ORDER UNDER SECTION 96 (2) OF ACT, III OF 1901.

With reference to his application, dated 15th April 1918
 Mr *Bhaji D. Newandram* is informed
 that the plan submitted by him for building a *lungalow*
 on plot No 19^a, Survey Sheet 711
 situate in *Sea Field Road Civil Line*
 Quarter, is approved, and permission to build in accordance therewith is
 granted. The building to be erected subject to the By-laws and Rules of the
 Municipality.

SHOWING PROPOSED BUNGLOW
ON PLOT NO 192 SHEET FII
CIVIL LINE QUARTERS
SCALE 1/4" = 1' INCH

PLAN
SHOWING PROPOSED BUNGLOW
ON PLOT NO. 19A SHEET FII
CIVIL LINE QUARTER
SCALE 8 FT = 1 INCH

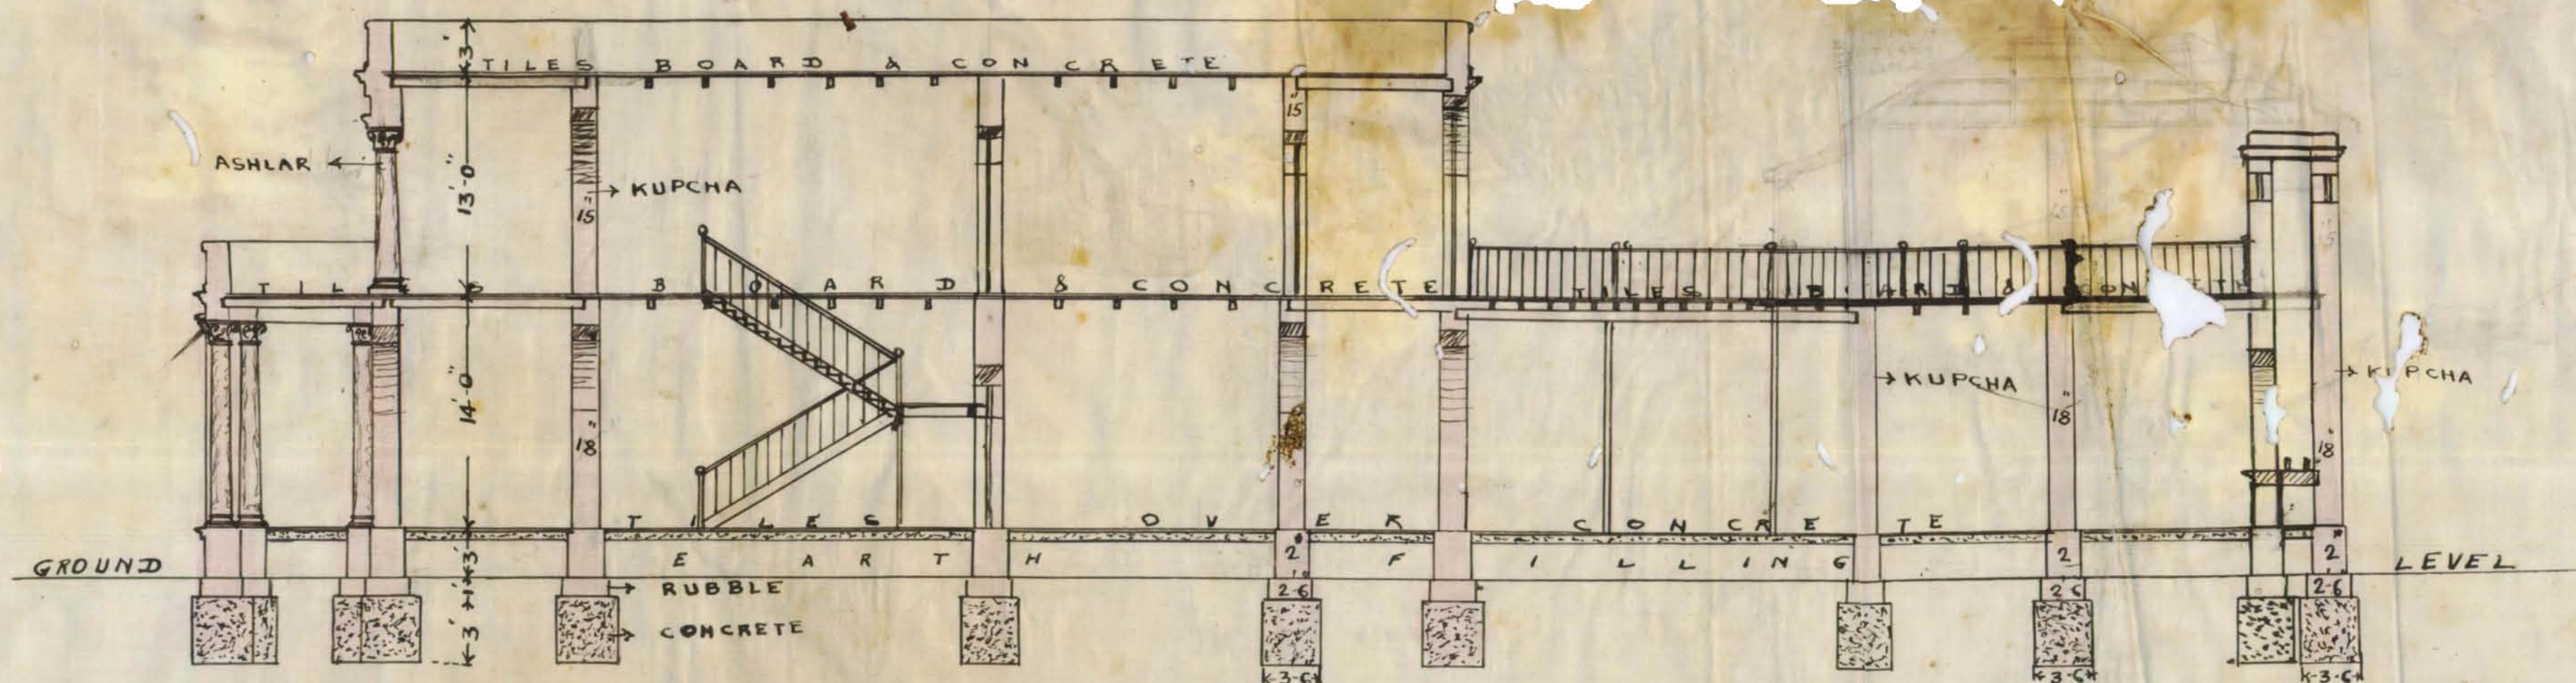
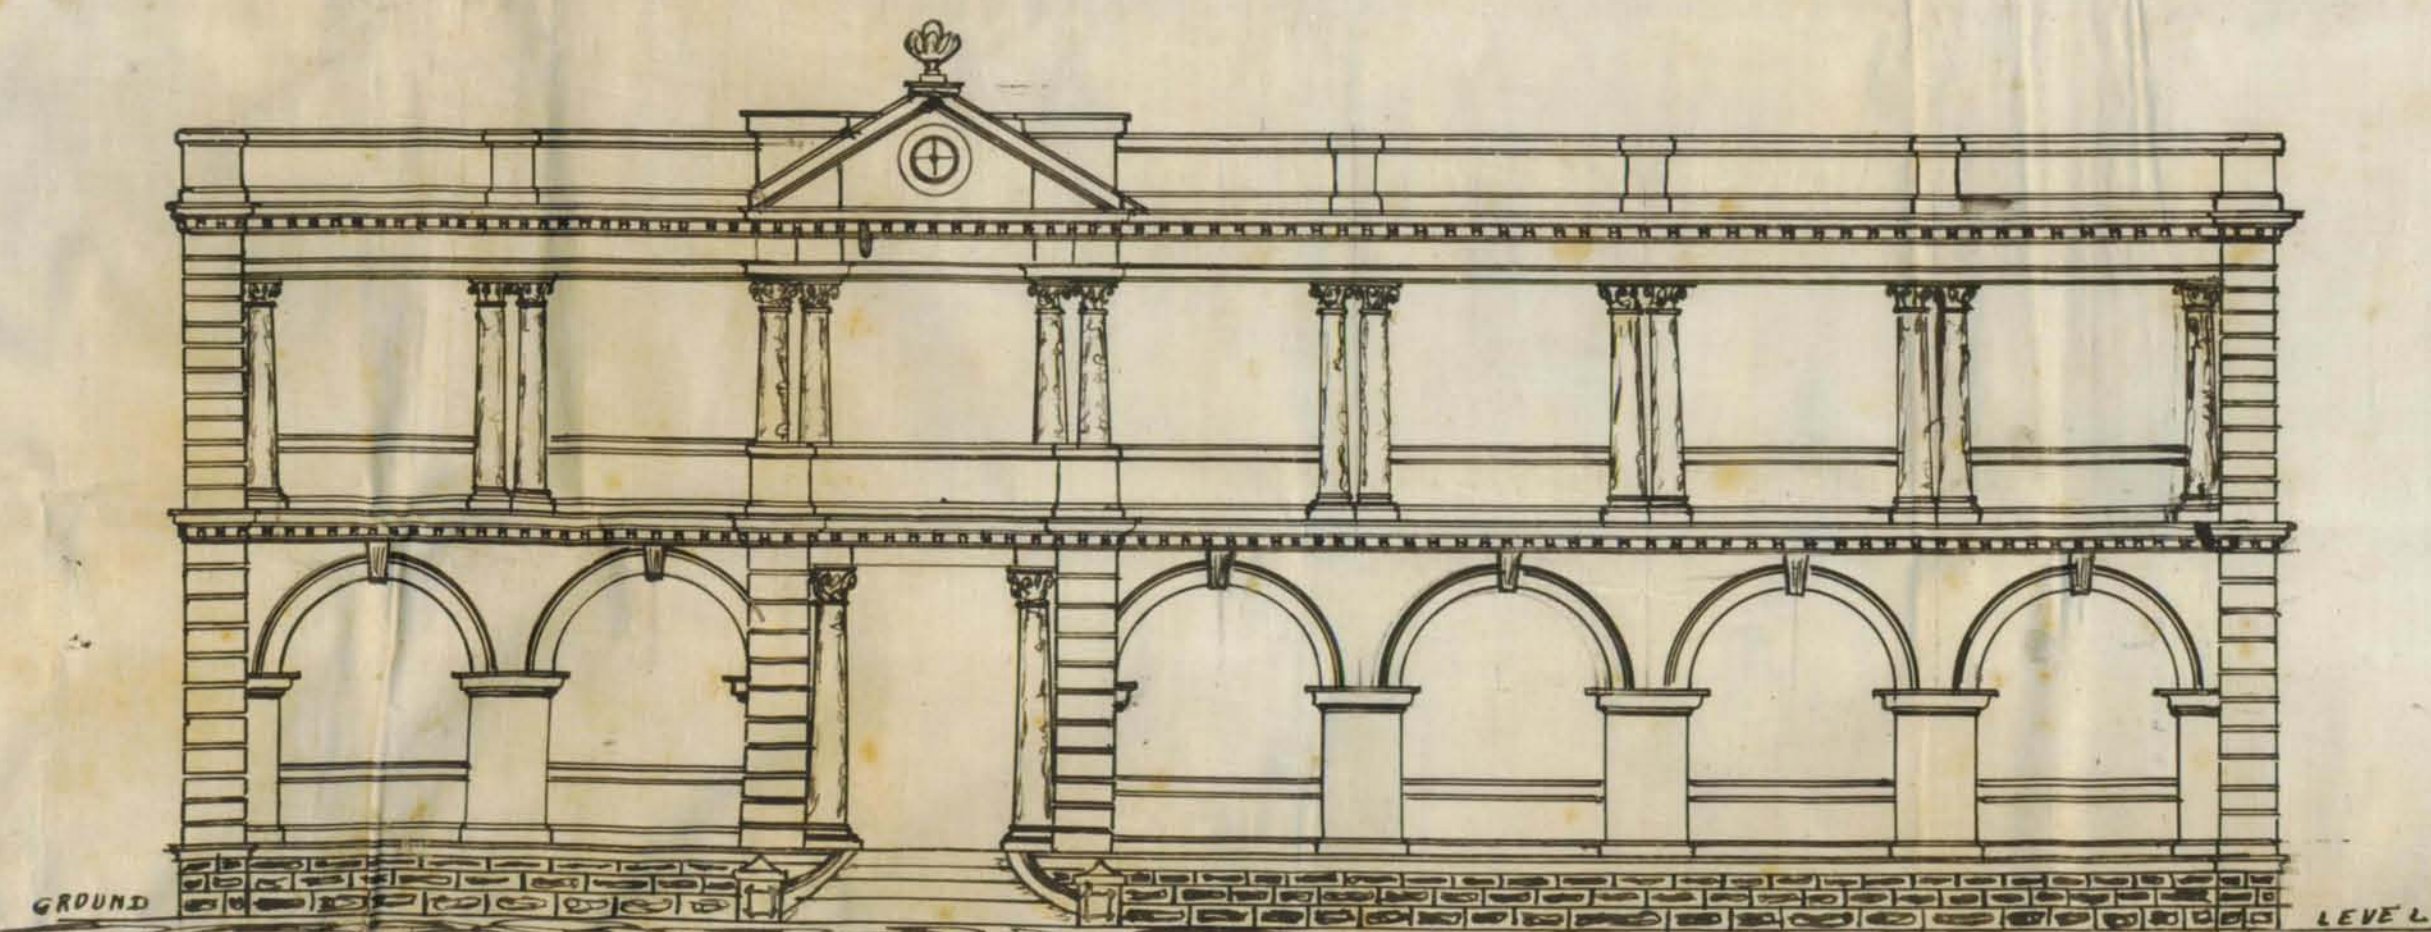
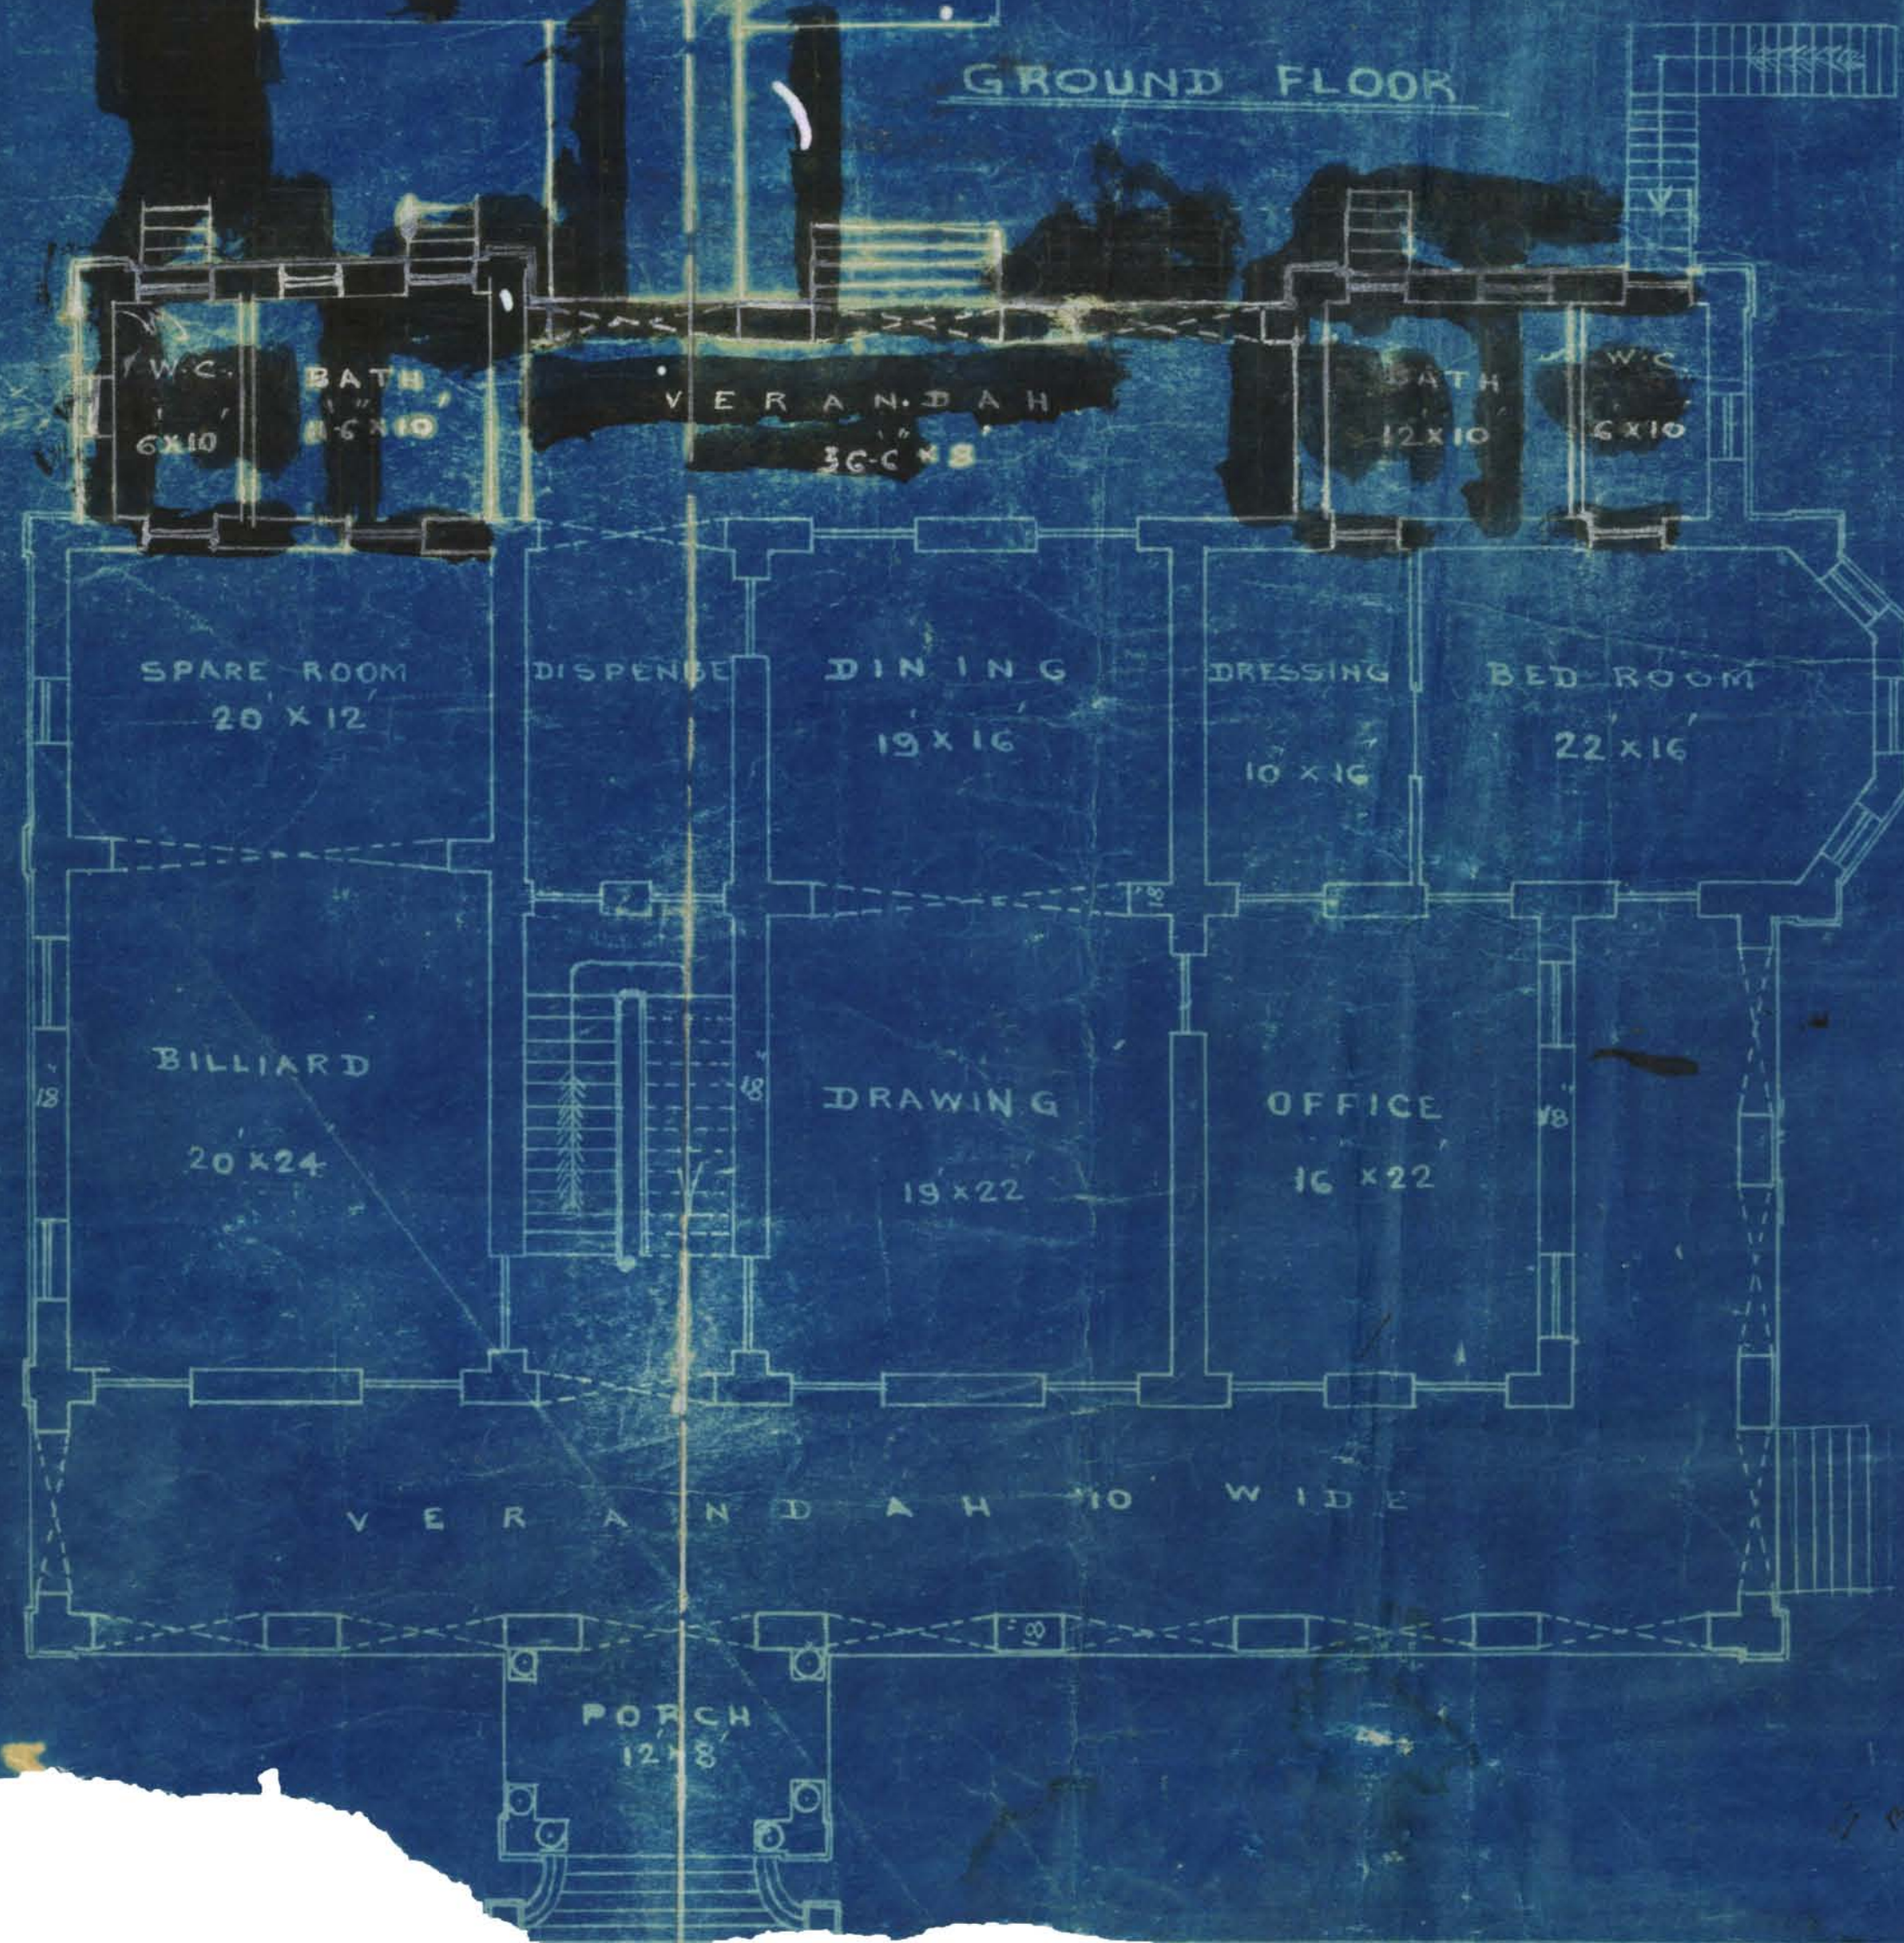
Remarks See. With reference to this I have to report
that the applicant wants to build a
bungalow with outhouse - This is a large
area to be covered with bungalow & outhouse.
Yours obediently

Given the area of the plot, the area covered with buildings
shows up on the ground. 1/27/18

With reference to
 your endorsement I beg
 to report that area of the
 plot is 420 square yds
 and the proposed
 building is 1024.
 square yds.
